Regional Municipality of Halton

New North Oakville Transportation Corridor and Crossing of Sixteen Mile Creek

Appendix B-2: Correspondence

Subject: **New Burnhamthorpe Road (Regional Road 27) Transportation Corridor
and Potential Future Bridge Crossing of Sixteen Mile Creek
Class Environmental Assessment Study
Regional Road 25 to Ninth Line (Regional Road 13), Town of Oakville**

Bridge Options

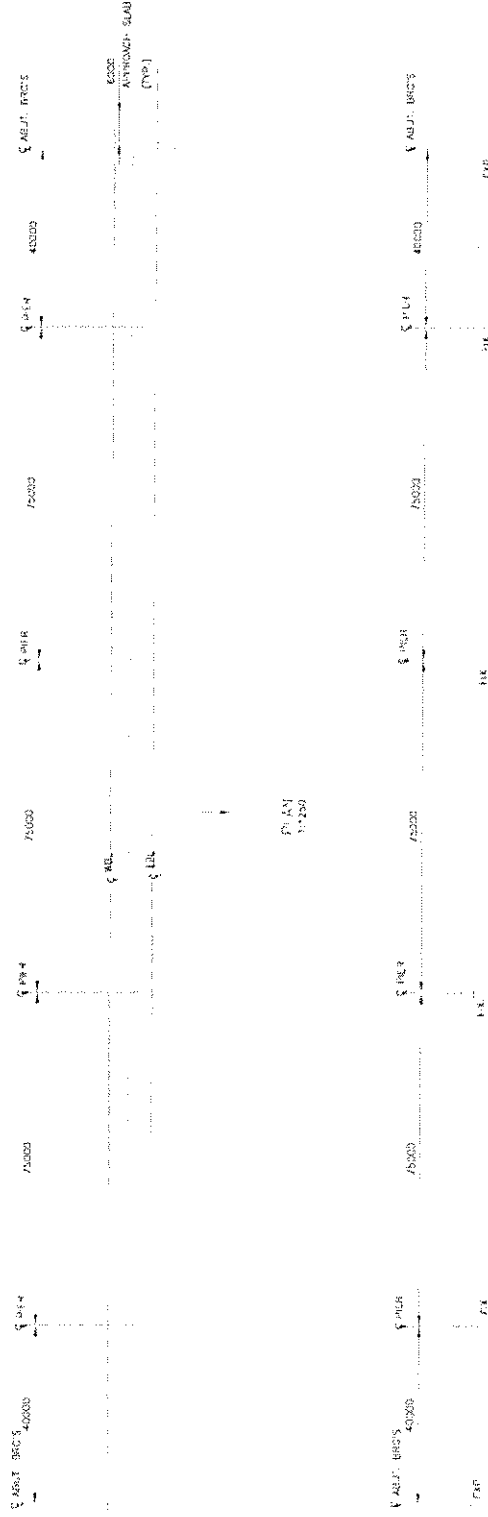
- Crossing spans range from 300m to 800m, depending on location.
- Different bridge options were identified for both 300m and 500m crossing lengths to determine feasibility:
 - Conventional Girder Bridge
 - Similar to 407 bridge type at creek crossing
 - 4 to 6 piers in valley
 - Cable Stayed
 - 2 towers in valley
 - 40% higher cost than conventional bridge
 - Suspension
 - no in-valley work
 - Twice the cost of conventional bridge
